Errata to ADS528x, Data Sheet Literature Number SBAS397

Revision Identification

Figure 3 Description of LVDS Timing Diagram Status for Final Version

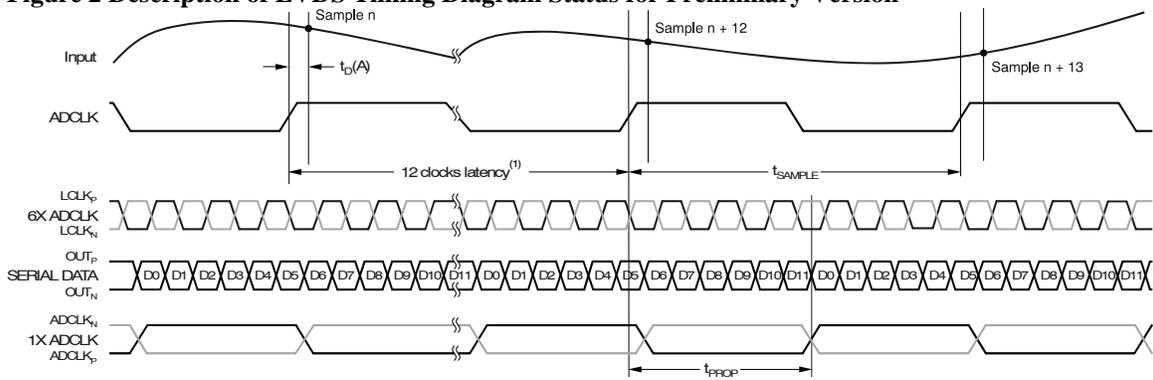
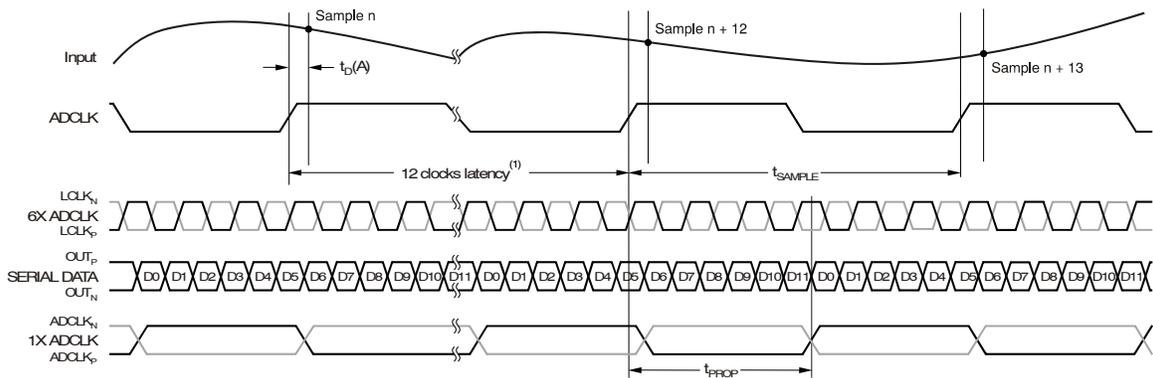
- 1) Inverse polarity of LCLK_N and LCLK_P.

The timing diagram for the LVDS signals on the preliminary prototype version is shown in Figure 2. However, Page 6 of the ADS528x data sheet (SBAS397, published December 2006) shows an LVDS timing diagram that matches Figure 3, which is the way it will appear in the final prototype version of the silicon.

Note the inversion in polarity of LCLK_P and LCLK_N in Figure 3, as compared to Figure 2. The first edge of LCLK_P after the rising edge of ADCLK_P will be a falling edge in the final prototype version, as is the case in the ADS527x family. The polarity inversion can also be described as a phase change of 180 degrees.

- 1) If the customer's prototype has built-in deskew capability, it is expected that there will be no impact to the deserializer in this revision. If deskew capability is not available, and the customer is using samples of the preliminary version for prototype development, it is recommended that the customer develop the prototype according to the timing diagram shown in Figure 2 (preliminary prototype version), and build in the capability to handle the polarity inversion of $LCLK_P$ and $LCLK_N$ on the final version.
